AMENDMENT NO. 1 JULY 2001

IS 14846 : 2000 SLUICE VALVE FOR WATER WORKS PURPOSES (50 TO 1 200 mm SIZE) — SPECIFICATION

FIG 4 VALVE CAP

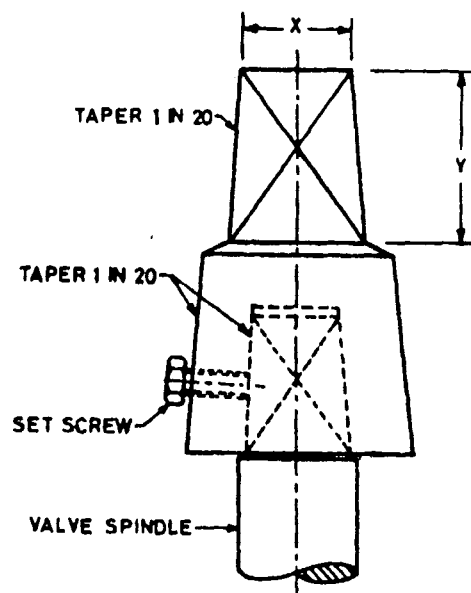
(Page 8, Fig. 4) — Substitute the existing Fig. 4 by the following:
